# SERVICE BULLETIN

M-955

SEPTEMBER 8, 1987

## 1340 ENGINE PINION GEARS, 1988 MODELS

Figure 1. Gear Marking

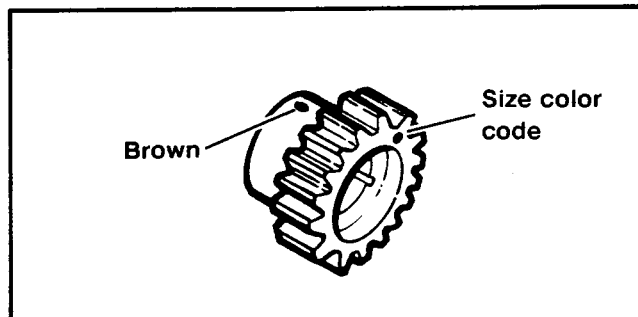
3. See Figure 1. The gear color code is marked on the face of the gear with one or two dabs of paint. The replacement gear you will receive from Harley-Davidson must have the same color marking. In addition the replacement gear will have a brown dot on the gear hub to avoid any possible gear mix-up by your technicians.

4. If the color code of the replacement gear is not the same as the gear you removed-call the Service Department for further instructions. The following tabulation lists the gear color codes and the corresponding Part No.
